THIRD FLOOR
SCALE 1:200

ROOF PLAN
SCALE 1:200

SUMMARY OF CHANGES

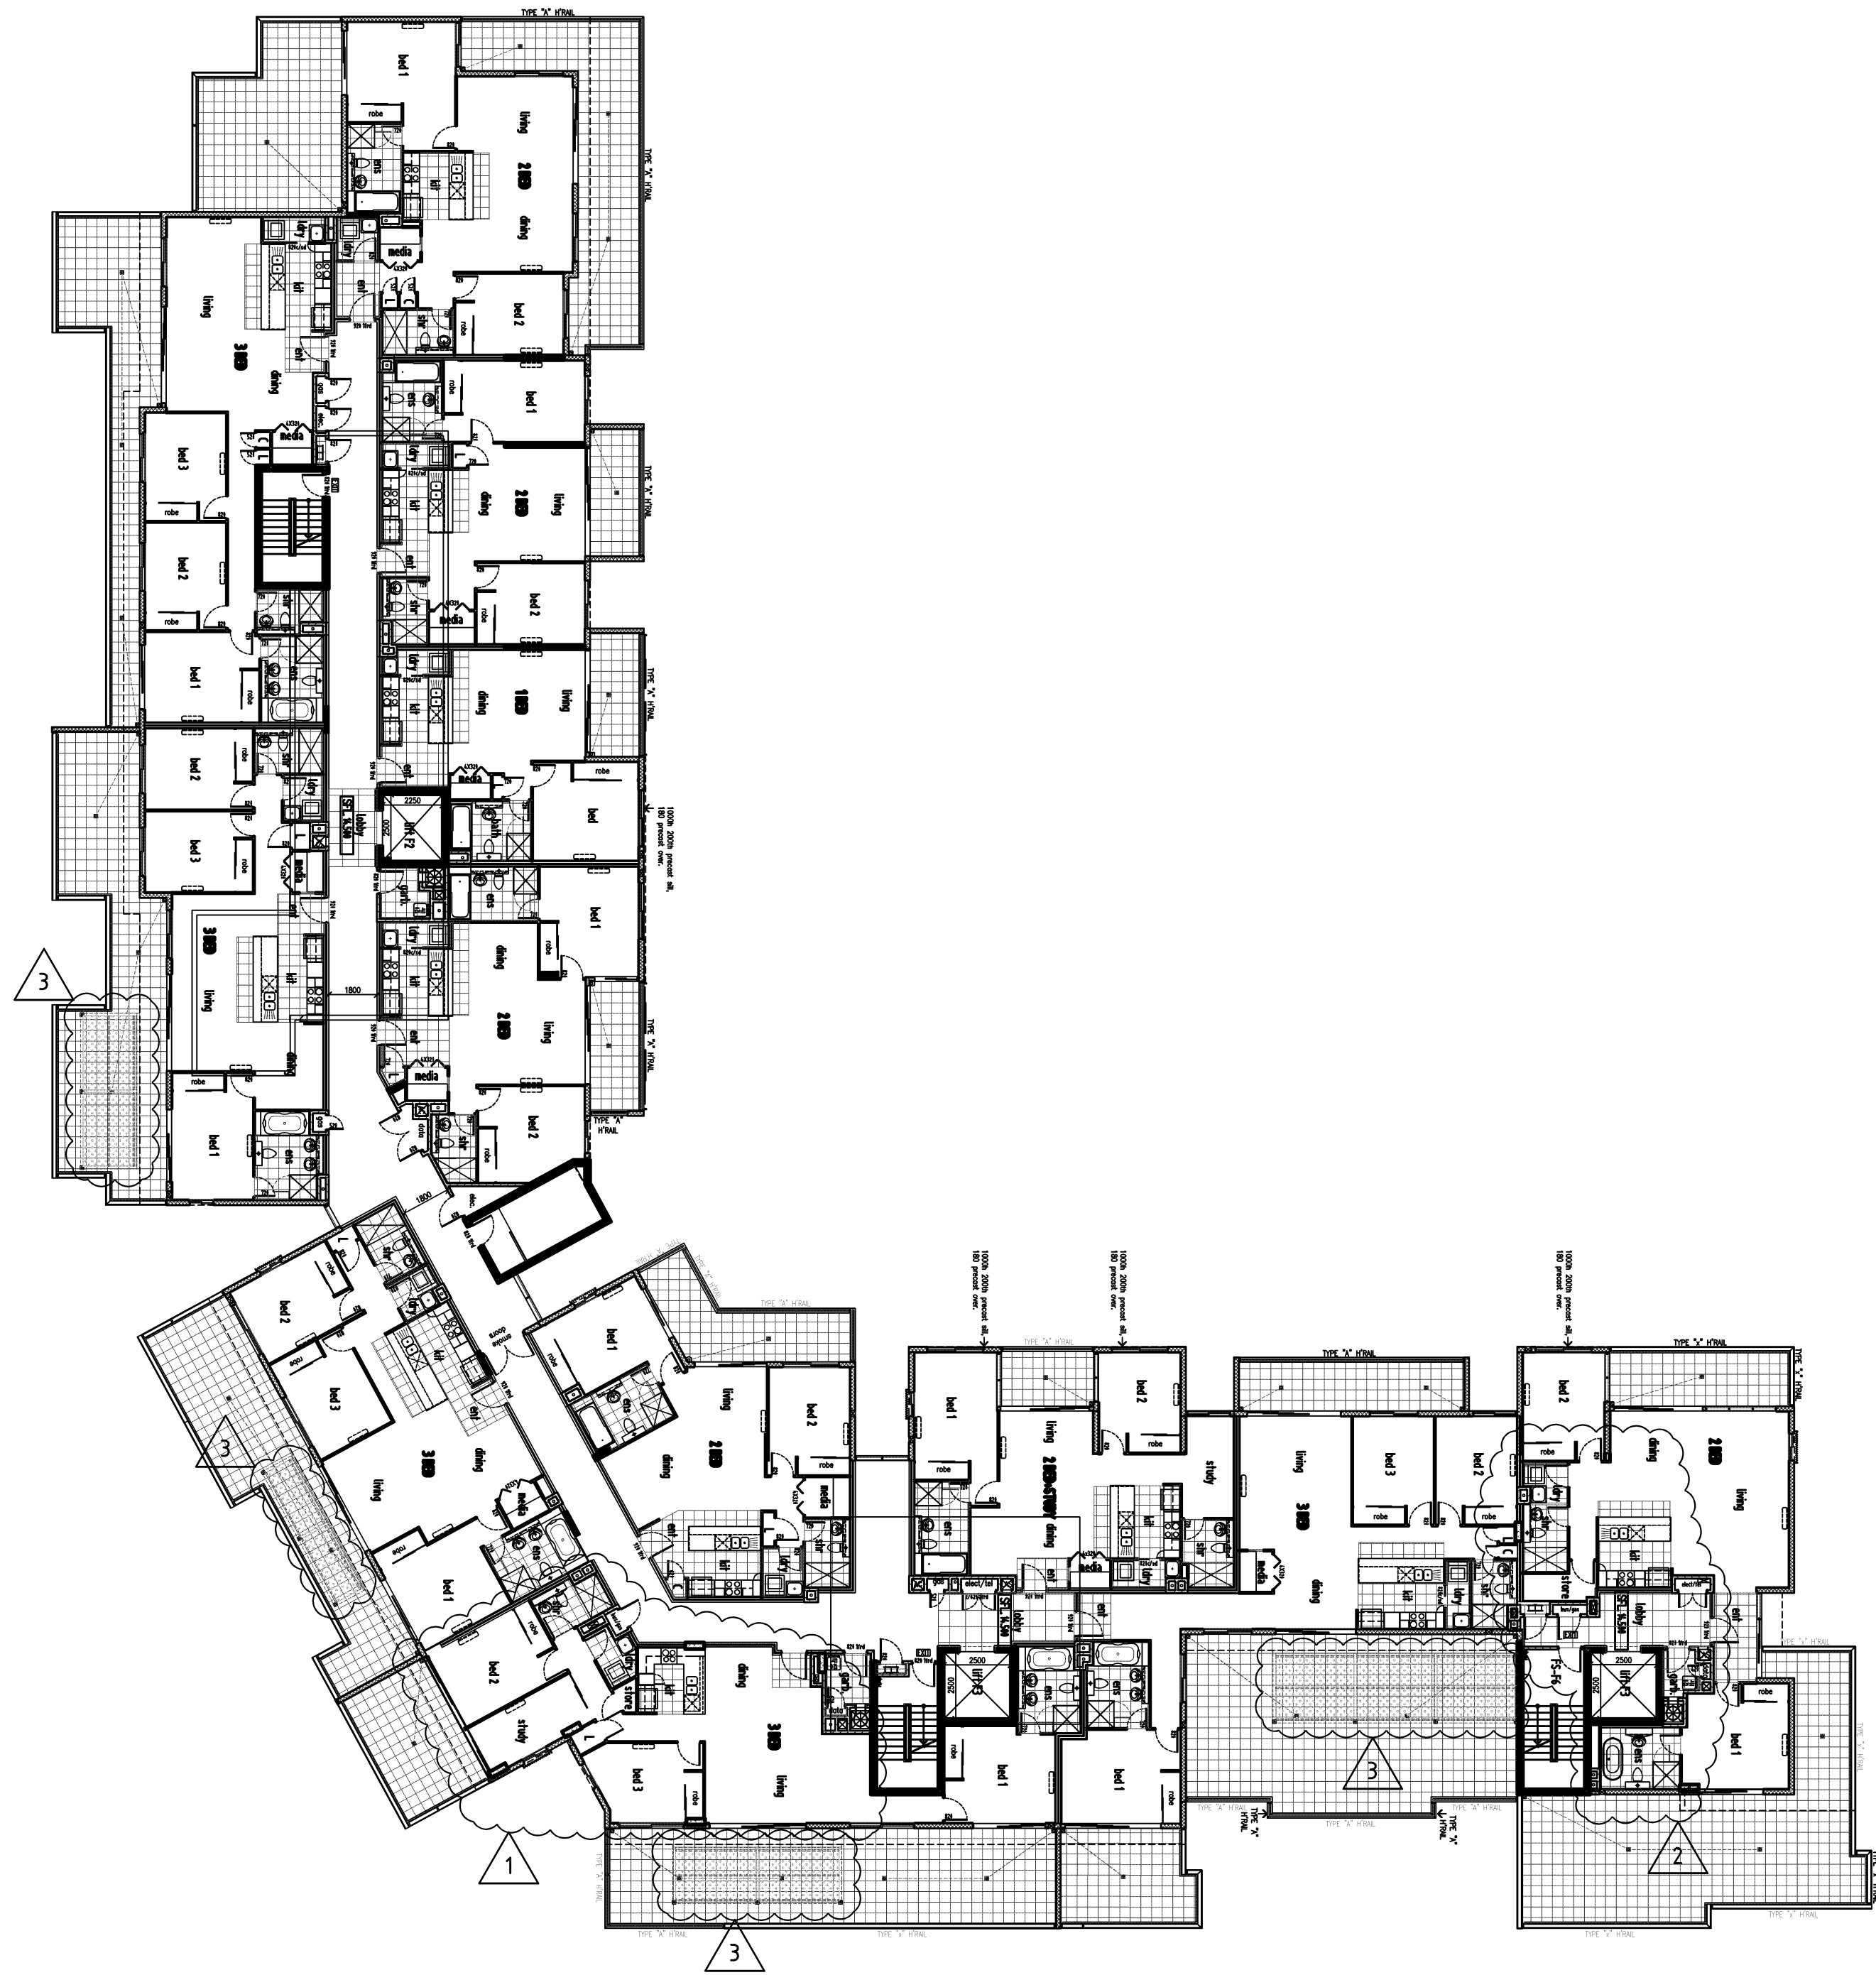
1. UNIT 349 LAYOUT REVISED TO PROVIDE A STUDY;
2. UNIT 354 & FOYER LAYOUT RATIONALISED;
3. PERGOLAS ADDED TO TERRACES OF UNITS 347, 349, 350 & 353;
4. ROOF OVERHANGS REVISED; AND
5. RAISED ROOF SECTIONS ADDED OVER BALCONIES ON NORTH ELEVATION
